Whale Tail 2022 Annual Open Pit Geomechanical Inspection

March 17, 2023

**RE: Meadowbank Complex - Amaruq Site - 2022 Annual Open Pit
Geomechanical Inspection**

Observations - Phase 3 Southeast Wall (3)

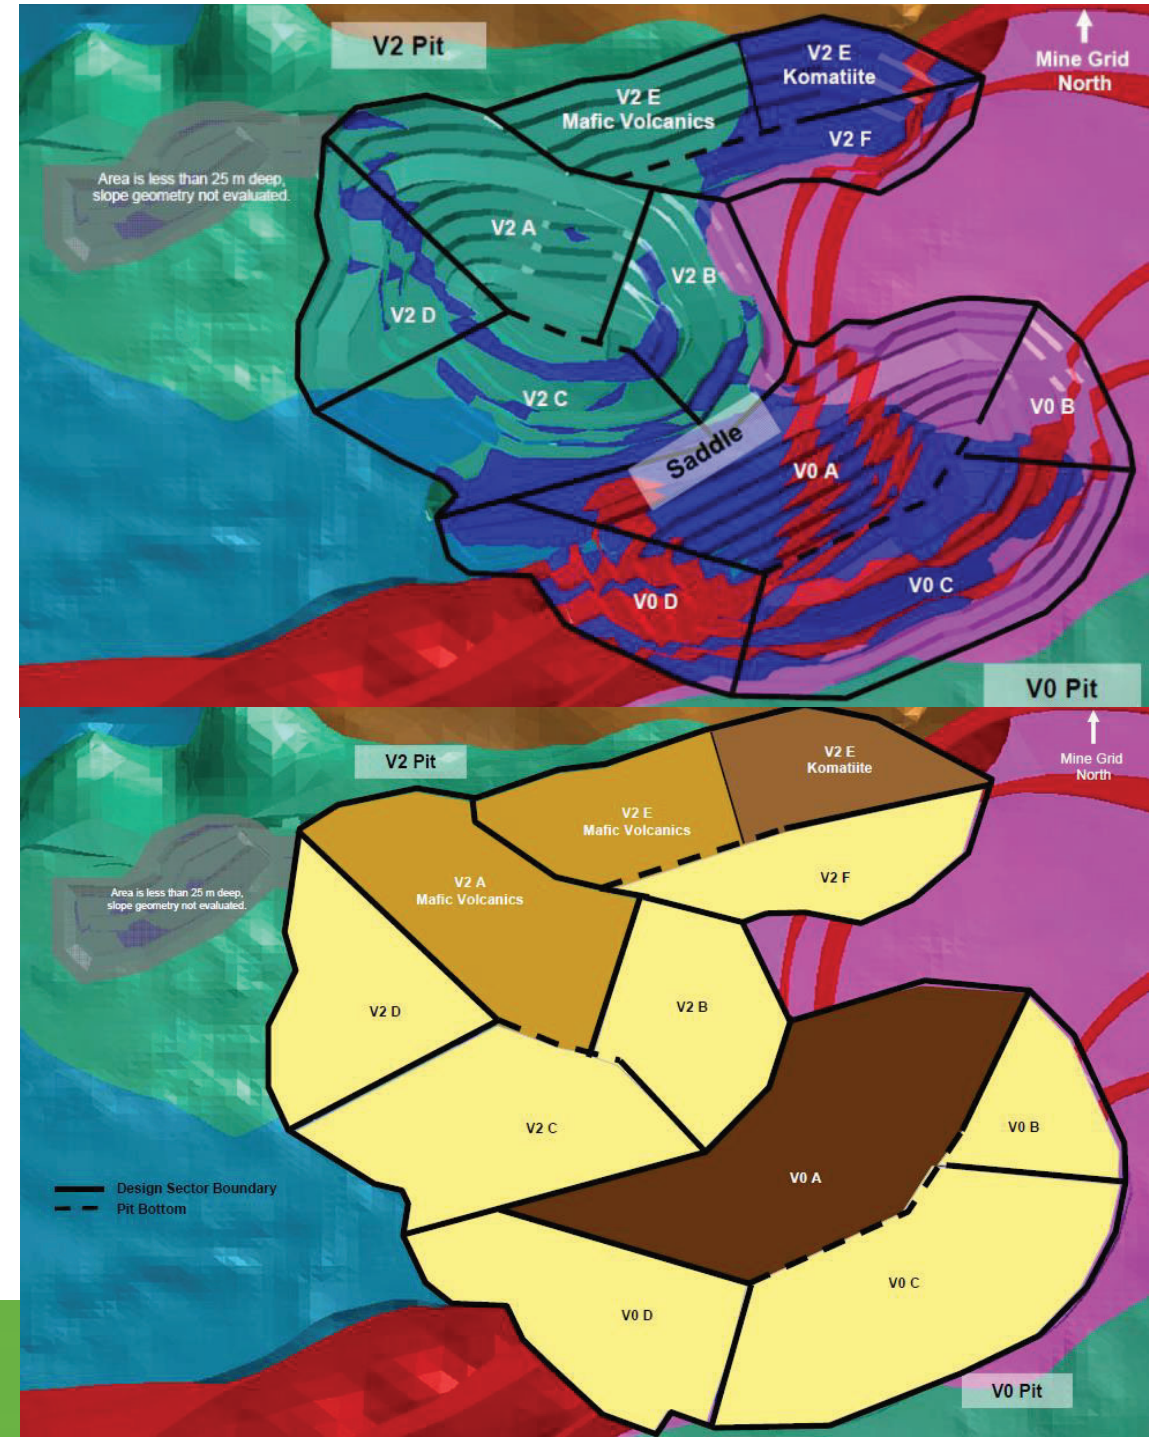
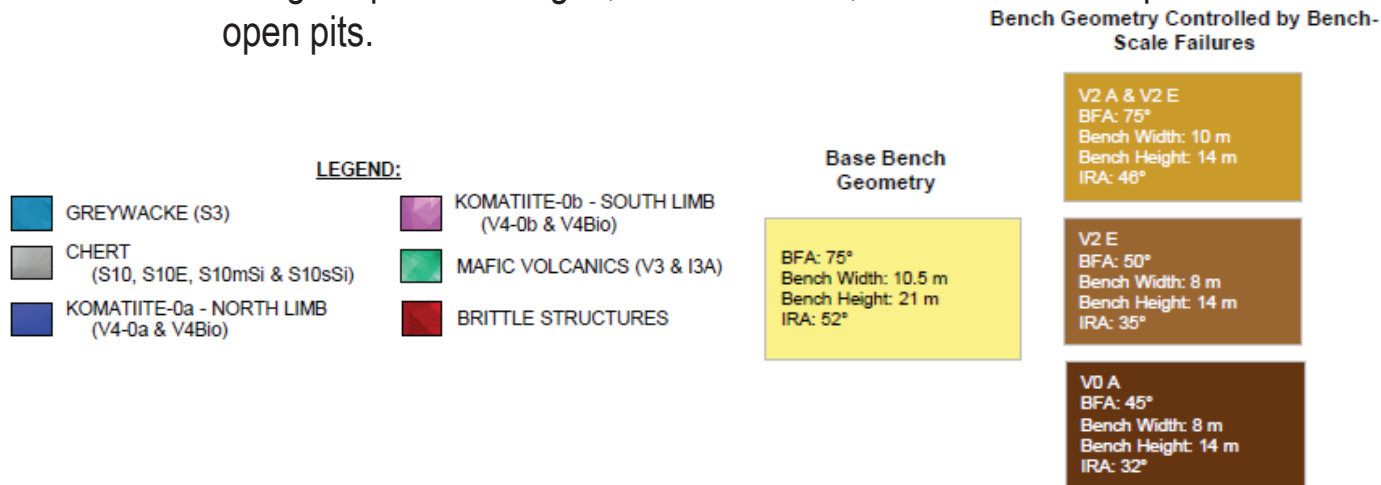
- The first flitch of the third bench had been established and drilling of the second flitch was in progress at the time of the visit. The bench is planned to be triple-benched. Pre-shear was used.

- The central portion of the bench has performed reasonably well (photo at right). Some crest loss, but half barrels visible over most of the face.
- The eastern portion of the bench has failed back to Joint Set C over almost the full height of the bench (photo at left). It is understood that this portion of the bench was scaled heavily, however some loose slabs were observed on the face that should be removed.

- It is understood that the Rock Mechanics student was tasked to do the Bench Approvals for this sector. Given the importance and challenging nature of this sector, it is recommended that the Bench Approvals for this area only be done by experienced personnel.

- It is not clear if the design BFA of 75° will be achievable for this sector. The remaining flitches of this bench need to be monitored and their performance documented. Once the bench is complete, a review should be completed to assess if the bench design is achievable or if it needs to revert to the shallower geometry (i.e., BFA of 50°).

Observations - Northwest Wall

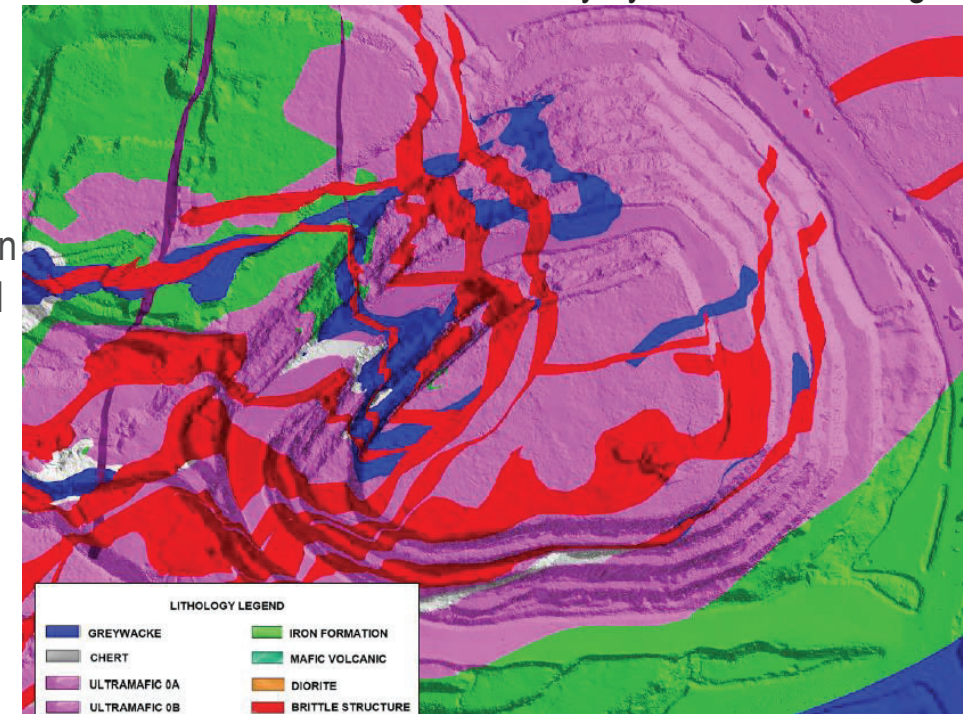
- The benches at the southern end of the upper wall failed back to the foliation during development. In some cases, there is effectively no catch bench width remaining.
- Mining of the IVR V2 open pit has resulted in spillover onto the northwest wall. The mine has adjusted the blasting practices to reduce this, but spillover is expected to continue.
- A rockfall berm has been established along the inside of the ramp and has capacity. The rockfall berm will need to be monitored and cleaned out as required as mining of IVR V2 continues.
- Mining of IVR V2 will ultimately remove the upper two to three benches of this wall, which will reduce the rockfall hazard in the long term.
